Nomination Form
Anadromous Waters Catalog

Region Southwest USGS Quad(s) Kodiak A-4
 Anadromous Waters Catalog Number of Waterway 258-52-10014
 Name of Waterway Sculpin Creek USGS Name Local Name
 Addition Deletion Correction Backup Information

Nomination #	<u>140222</u>	<u>James J. Hasbrouck</u>	<u>9/3/2014</u>
Revision Year:	<u>2015</u>	Fisheries Scientist	Date
Revision to:	Atlas _____ Catalog _____ Both <u>X</u>	<u>Will Frost</u>	<u>9/3/14</u>
Revision Code:	<u>C-5, B2</u>	Habitat Operations Manager	Date
		<u>JF</u>	<u>6/10/14</u>
		AWC Project Biologist	Date
		<u>TA</u>	<u>9/5/2014</u>
		Cartographer	Date

SUBJECT: Trip Report, May 2014 Old Harbor Airport Project

Figure 1

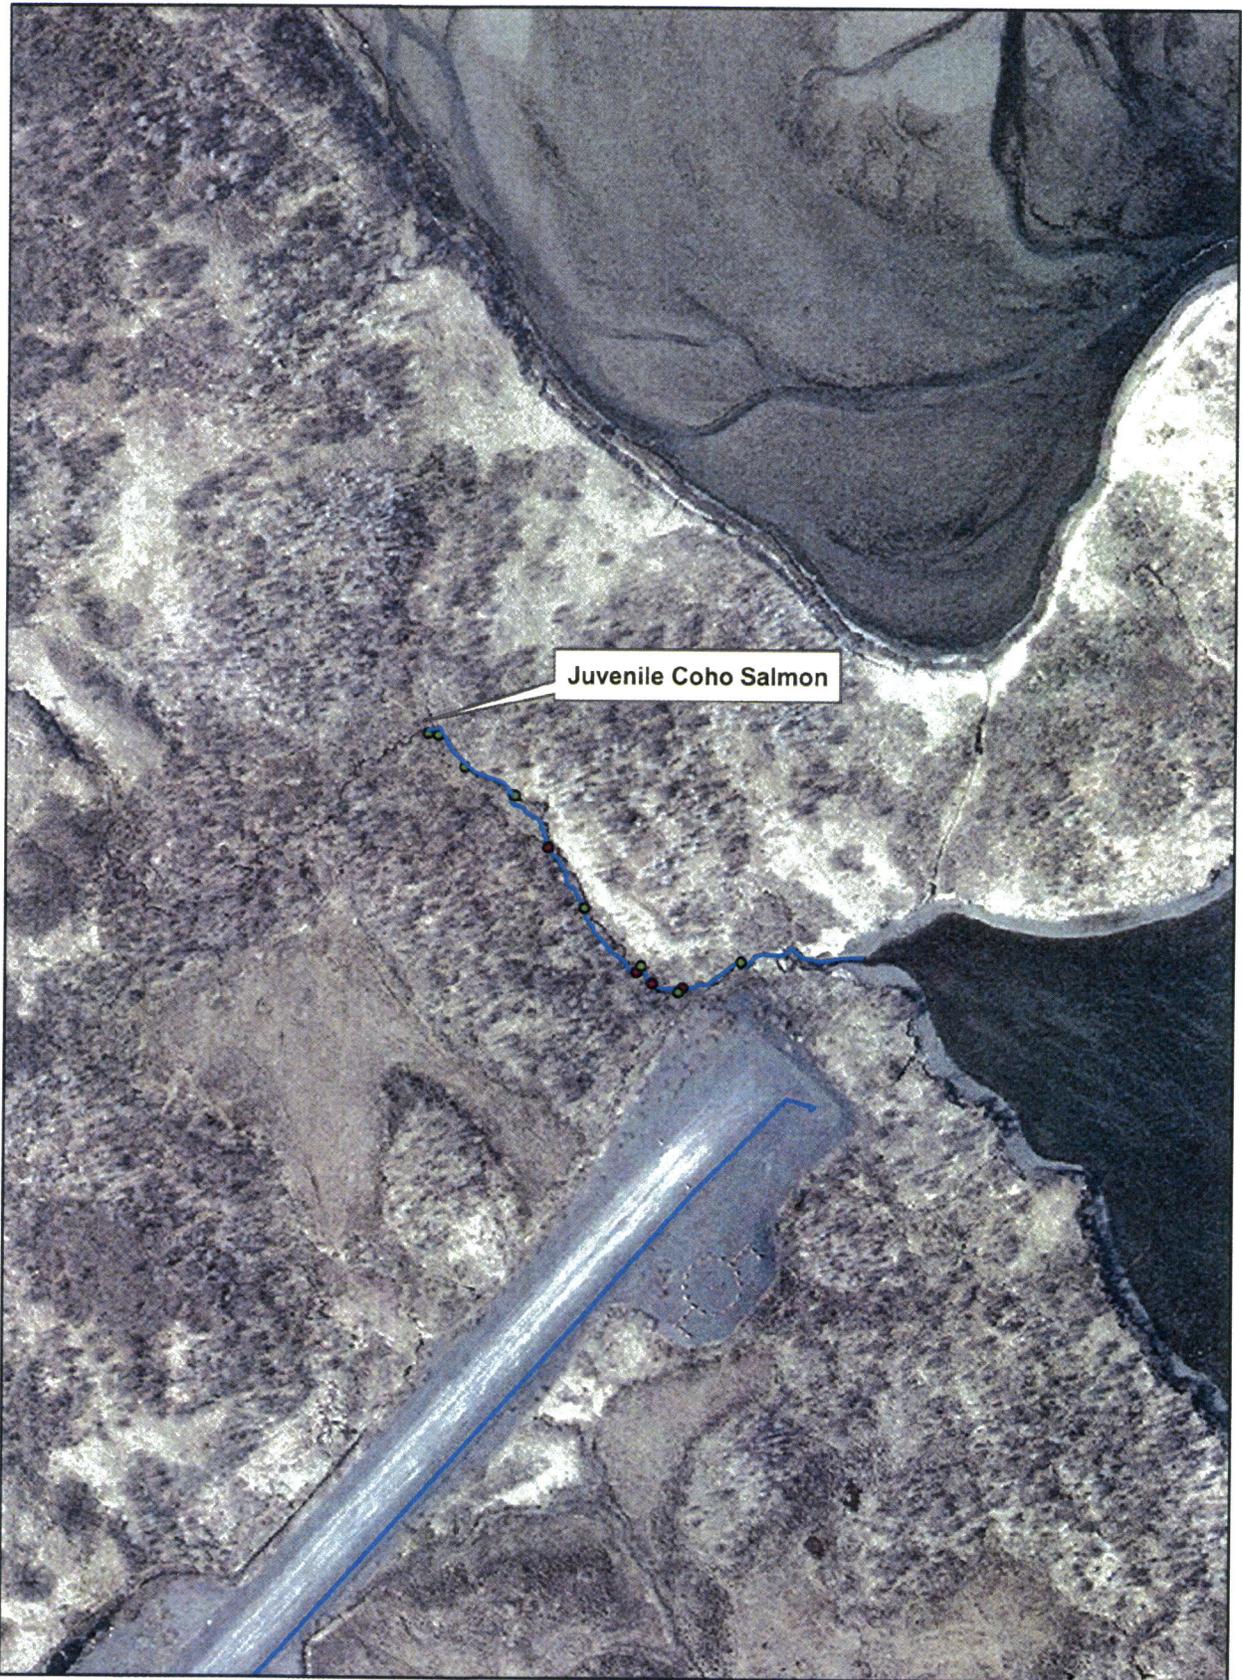
Relocate stream channel and lower point add pink salmon rearing
 Sculpin Creek was relocated for the Old Harbor Airport project. I used a GPS to locate the new stream channel. I observed and captured y-o-y pink salmon in the new stream channel (Figure1). See the May 17, 2014 trip report.

change lower stream channel & lower pt location for 258-52-10014
& add pink salmon rearing, use 2015\noms\frost\05_17\tracks.shp
(purple line) & arc2015 (orange line) to update AWC (blue line) hydrography

Figure 1

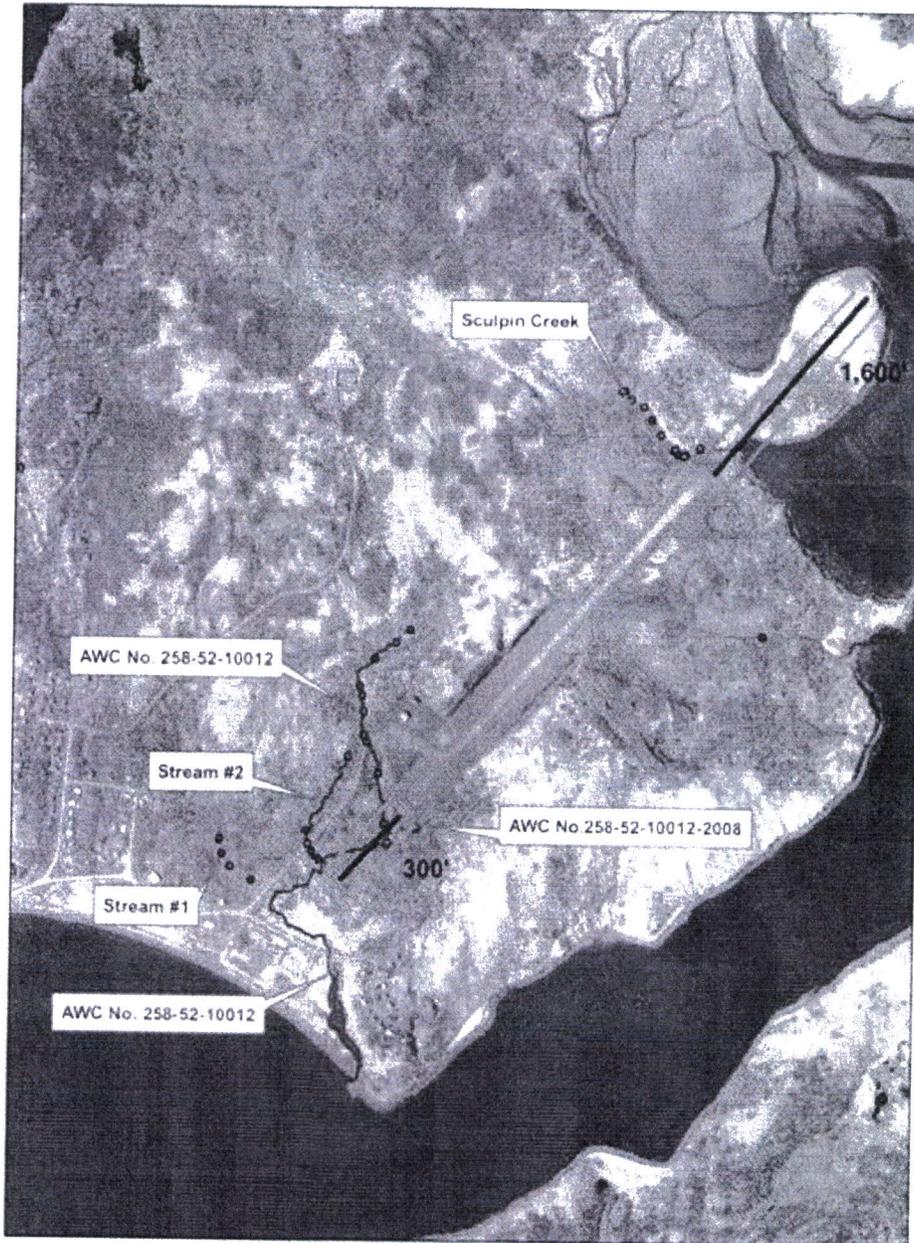
The location of Stream No. 258-52-10012 is incorrectly located in the Anadromous Waters Catalog. I used a hand held Garmin Global Positioning System unit to correct the stream location by walking the stream channel from tidewater to its headwater. The corrected stream location will be nominated to the Anadromous Waters Catalog (Figure 1).

We sampled Sculpin Creek located on the north side of the runway (Figure 1). Sculpin Creek flows into Midway Bay. We started at tidewater and worked upstream about 840 linear feet. We captured and released 20 juvenile coho salmon, 36 Dolly Varden, and over 35 sculpin. The stream was sampled during the May sampling effort. Based on the May and June sampling efforts, Sculpin Creek will be nominated to the Anadromous Waters Catalog.
